RE: Blythe Energy Transmission Line Project Request for Staff Approved Project Modification (99-AFC-8C)

Request for Staff-Approved Project Modifications (99-AFC-8C)

Minor Modifications to the Blythe Plant Connection to the Generation Intertie

Figure 2-1 Isometric Drawing of Blythe Interconnection using Proposed GIS

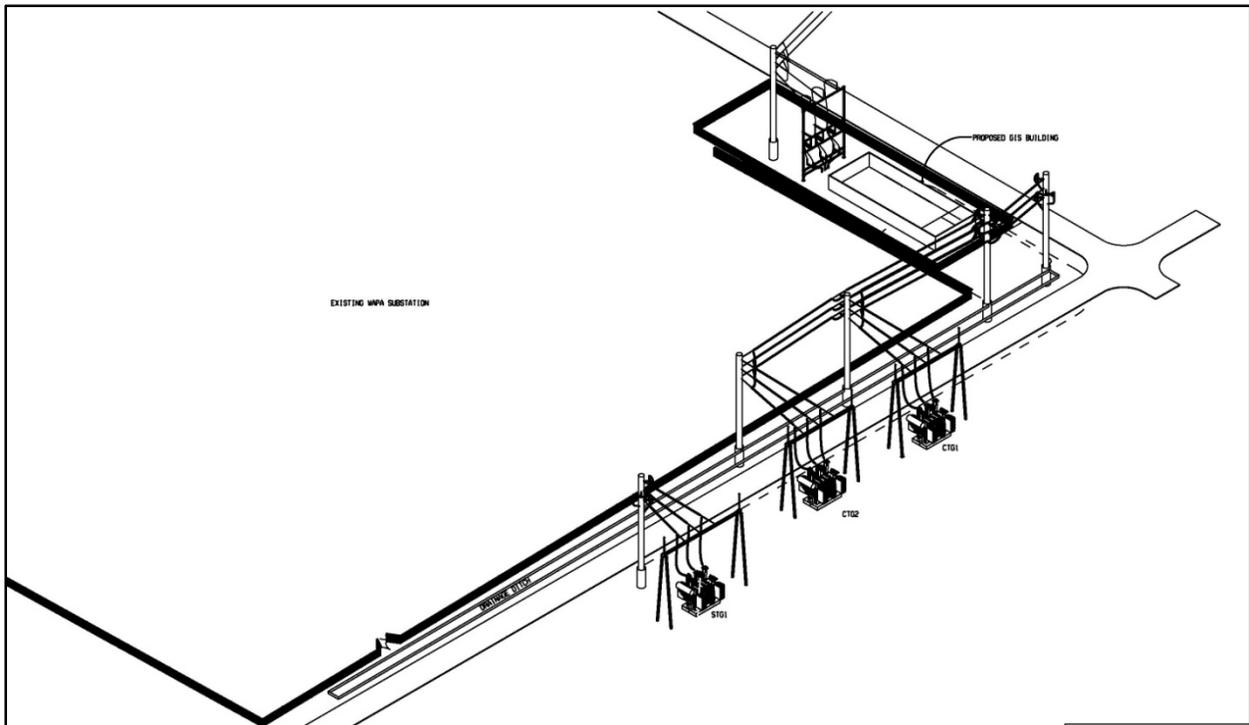
As part of the proposed modifications described above, the current connection to the Buck Substation will be removed. One new 230kV underground circuit and two new 230kV overhead circuits will be installed from the existing GSU transformers over to a new 230kV gas-insulated switchyard that will be located on the south side of the Buck Substation in an already disturbed/graveled area (Figure 2-1). At the two existing combustion turbine generators (CTG) GSU transformer bays, the existing “A”-frame dead-end will be removed and a new “H”-frame will be installed to facilitate the connection to the 230kV underground terminations. At the steam turbine generator (STG) GSU transformer bay, a new H-frame tower will be installed and used in conjunction with the existing A-frame dead-end to facilitate the connection to the 230kV underground terminations. The new 230kV circuits will be routed south up the access road and then east into the new switchyard that will be located between the main plant south side access road and the existing Buck Substation (see Figure 2-1).

Figure 2-2 Section of Proposed GIS and interconnection

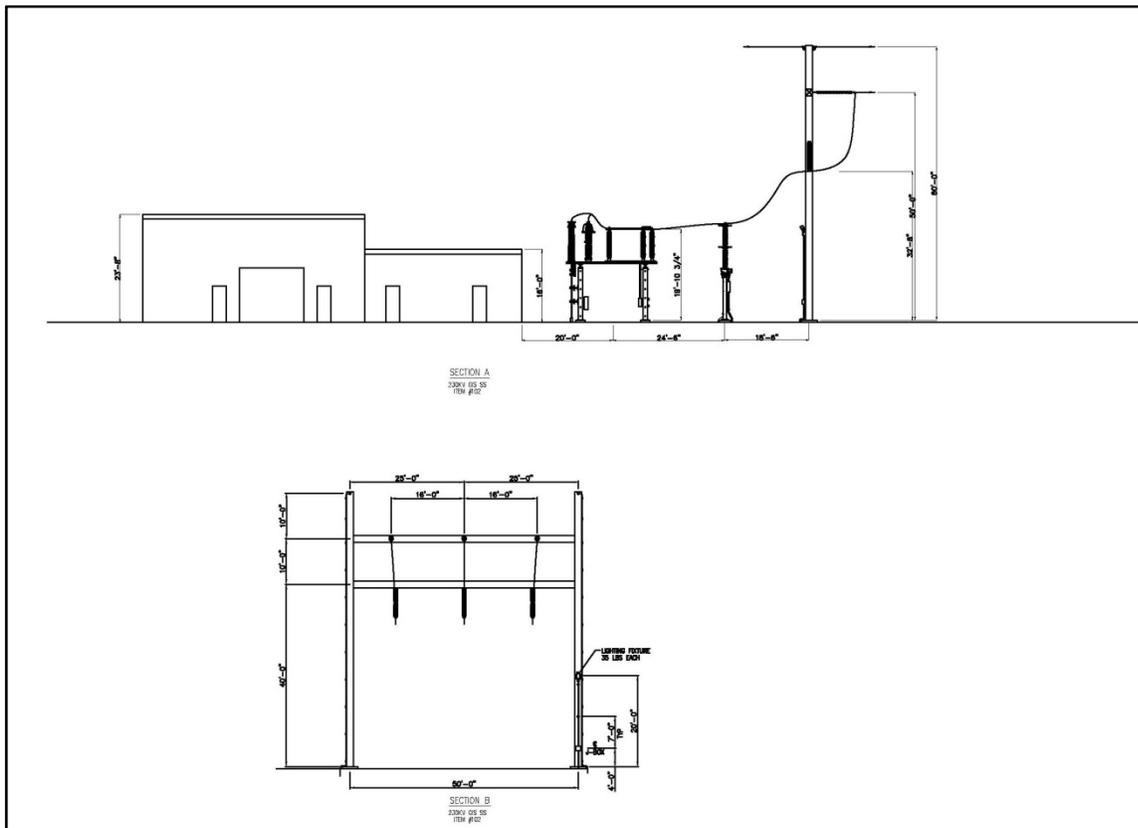
An elevation drawing of the new switchyard is shown in Figure 2-2. The new 230kV switchyard will be configured as a four breaker ring bus; three positions will be used to bring in the circuits from the GSU transformers and the fourth position will be connected to the 230kV overhead Blythe Energy transmission line.

| SWITCHING ONE-LINE DIAGRAM | DRAWING NUMBER | E8-1 | | |

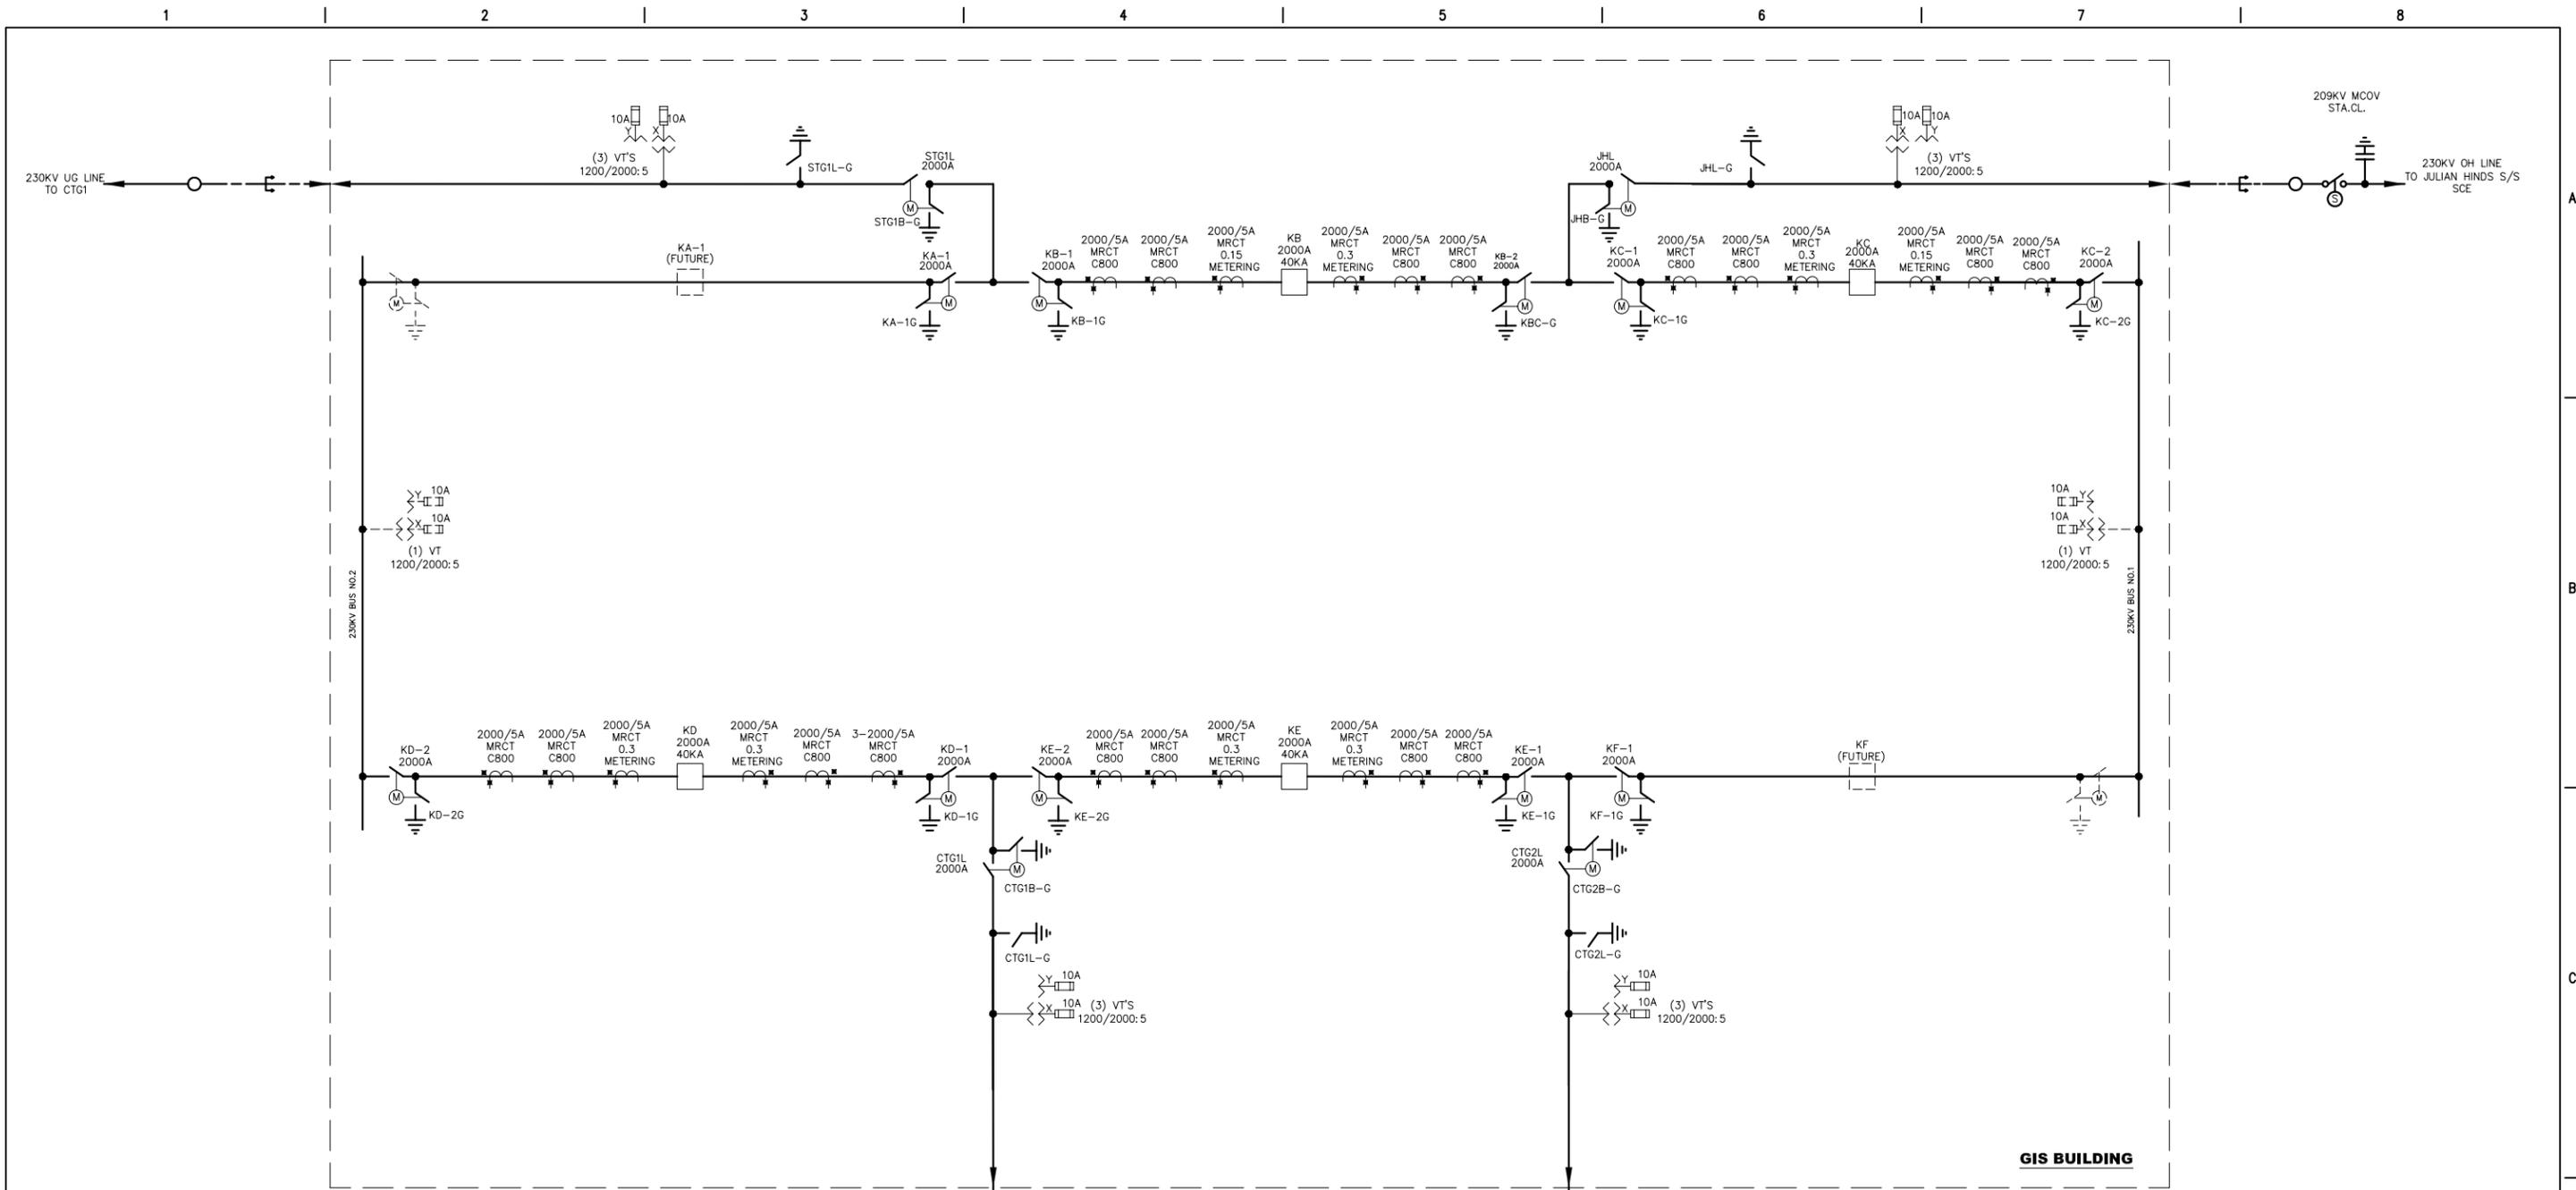
The following describes the steps necessary to finalize construct the GIS and to switch the interconnection from the Buck Substation to the GIS, providing thereby a connection to the SCE system through the BEPTL. Appendix B includes drawings showing the “as-built” condition of the BEP and BEPTL as interconnected at the Buck Boulevard substation. Appendix C includes drawings showing the general configuration of the GIS and interconnection after the proposed change. The work will be performed during one plant outage. The plant outage is scheduled to begin in March 2013 and last into April 2013 with a duration of 35 days – exact dates will be finalized as the target dates become closer.
